- **AIR CONDITIONING—NEW O-RING APPLICATIONS—THICKER O-RINGS FOR SPRING LOCK FITTINGS—SERVICE TIP**

**Article No.
96-20-8**

- **AIR CONDITIONING—SPRING LOCK COUPLING CLEANING PROCEDURE—SERVICE TIP**

Figure 1 - Article 96-20-8

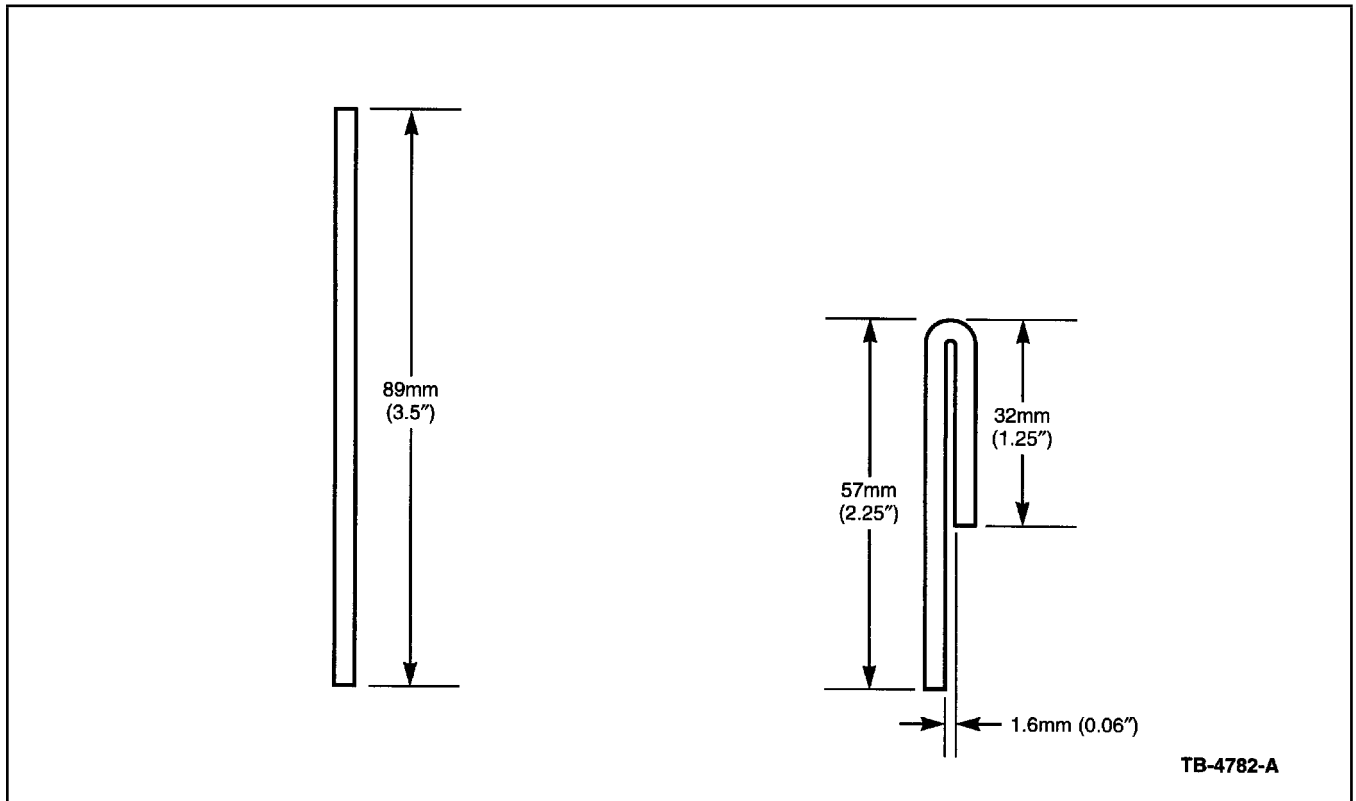
- b. Fabricate a cleaning tool (Figure 1).
- c. Determine coupling size and select the appropriate length of abrasive strip from the Step 4a table.
- d. Insert abrasive strip into the cleaning tool (Figure 2).
- e. Insert completed assembly into drill and tighten chuck securely.
- f. Coat the abrasive strip in appropriate refrigerant oil.
- g. Roll abrasive strip around cleaning tool (Figure 3).

Figure 4 - Article 96-20-8

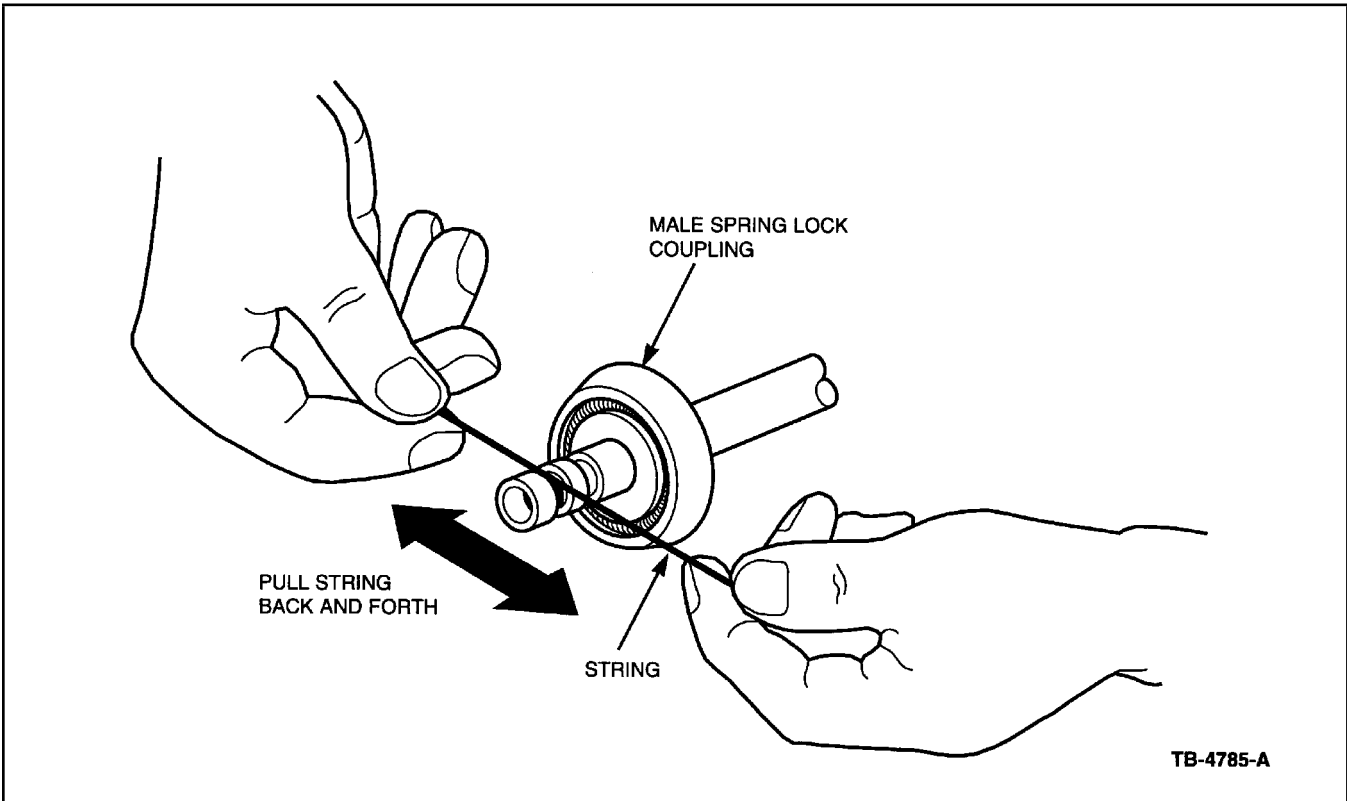
- i. Remove all cleaning residue from the coupling using a lint free cloth.
 - j. Inspect O-ring sealing surface for grooves. If grooves or scratches cannot be removed, replace the component.
5. Inspect the male SLC O-ring grooves for scratches, corrosion, or debris from O-ring deterioration. Remove any surface residue from the O-ring grooves by cleaning using the following procedure (Steps 5a-5b):
 - a. Loop the 12" length of natural fiber string around SLC and clean O-ring sealing surface (Figure 4).
 - b. Remove all cleaning residue using a lint free cloth.
